UNITED STATES PATENT AND TRADEMARK OFFICE

APPLICATION NO.	FILING DATE	FIRST NAMED INVENTOR	ATTORNEY DOCKET NO.	CONFIRMATION NO.
09/728,038	12/01/2000	Hung Chen	AMAT/3778/CMP/CMP/RKK	2584
44257	7590	01/03/2011		
PATTERSON & SHERIDAN, LLP - - APPM/TX 3040 POST OAK BOULEVARD, SUITE 1500 HOUSTON, TX 77056			EXAMINER GRANT, ALVIN J	
			ART UNIT	PAPER NUMBER
			3723	
			MAIL DATE	DELIVERY MODE
			01/03/2011	PAPER

Office Action Summary	Application No.	Applicant(s)	
	09/728,038	CHEN ET AL.	
	Examiner	Art Unit	
	ALVIN J. GRANT	3723

DETAILED ACTION

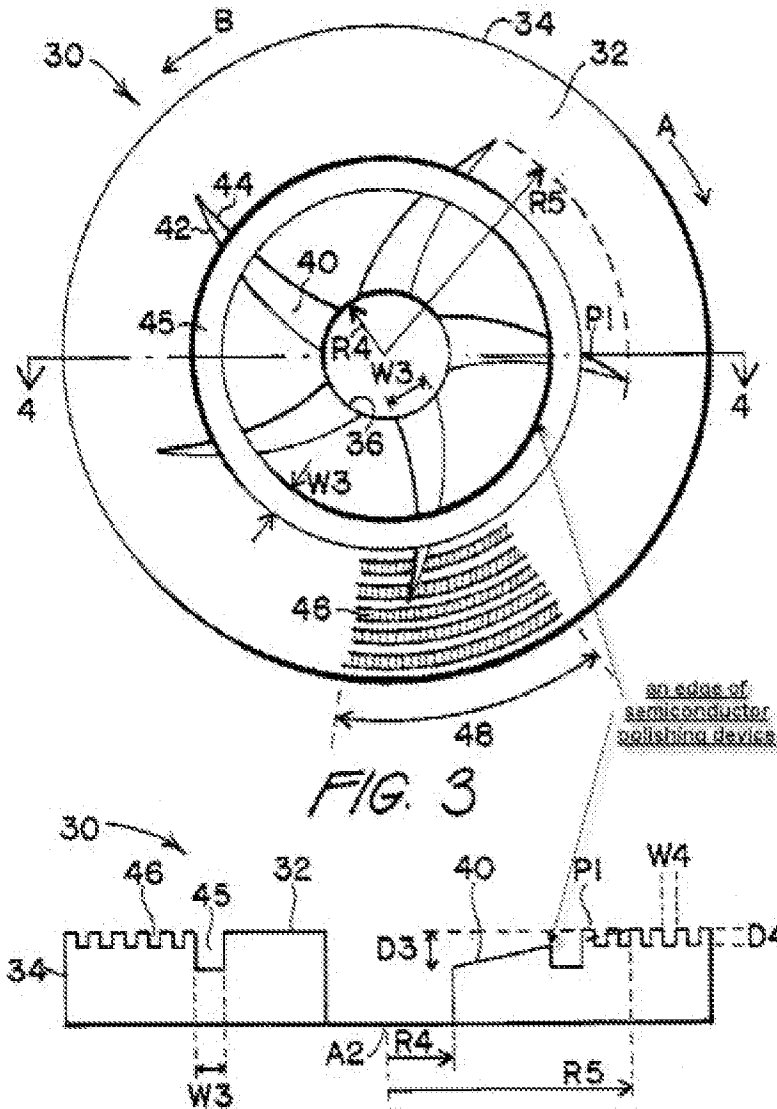
Regarding claims 8 and 42, see drawing below.

semiconductor polishing device to **an edge** of the semiconductor device in not convincing. The figure above discloses this feature.

- Applicant's argument that Burke does not teach a pad having a center is not convincing. The figures above clearly show a center.
- In response to Applicant's argument that extending the channel to **the edge** of Burke's pad would cause the slurry to flow past the wafer and off the pad, Applicant claims recite **an edge** of the pad and this feature is satisfied by Burke.

- In response to Applicant's argument that Burke does not teach *no point on the grooves is tangent to a radial line extending from a center of the substrate polishing pad* as recited in claim 15, Fig. 3 above show that no point on the grooves in question (i.e. 40) would have a tangent extending from the center. The other elements of claim 15 have been addressed above.
